RE: 223 Forrester Road

I reviewed the drawings and evaluated the neighborhood context. My comments and recommendations on the design are as follows:

EXHIBIT 5

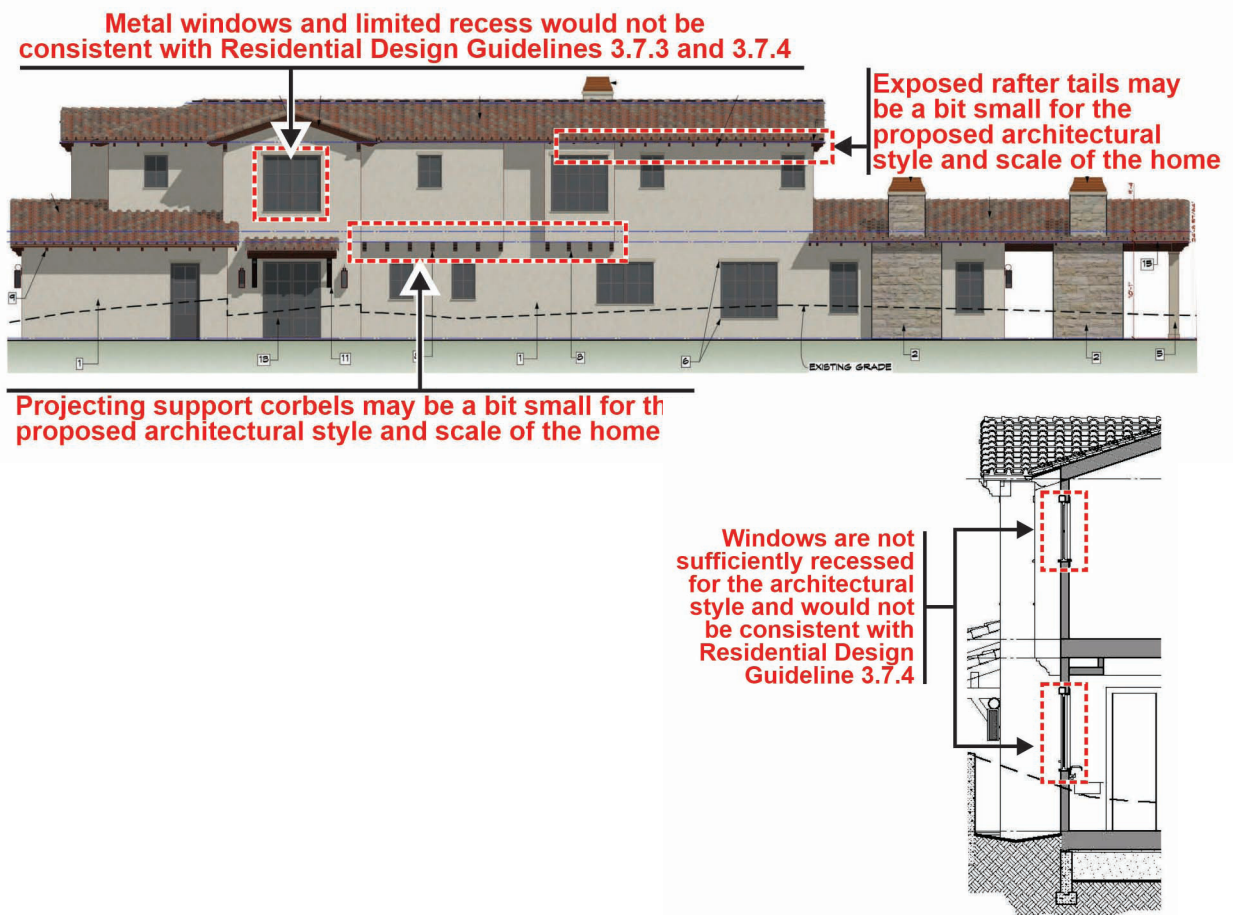
The site is quite large but the house is sited very close to the facing road which is common for nearby homes to the west on the uphill side of Forrester Road.

The proposed home is very well designed in an architectural Mediterranean Style with good attention to forms and details appropriate to the style. There are only a couple of details that I would suggest staff review further with the applicant.

1. Windows need further clarification to assure that they are consistent with Residential Design Guidelines 3.7.3 and 3.7.4.

- Windows are not sufficiently recessed from the exterior surface of the wall.
- Metal windows may be too small in sash section of for the style and scale of the house.
- No details are provided for the divided lite window grids.

2. Clarification is needed on the scale and shapes of the proposed exposed rafter tails and corbels. In some drawings they appear appropriate in size and scale but not so much in others.
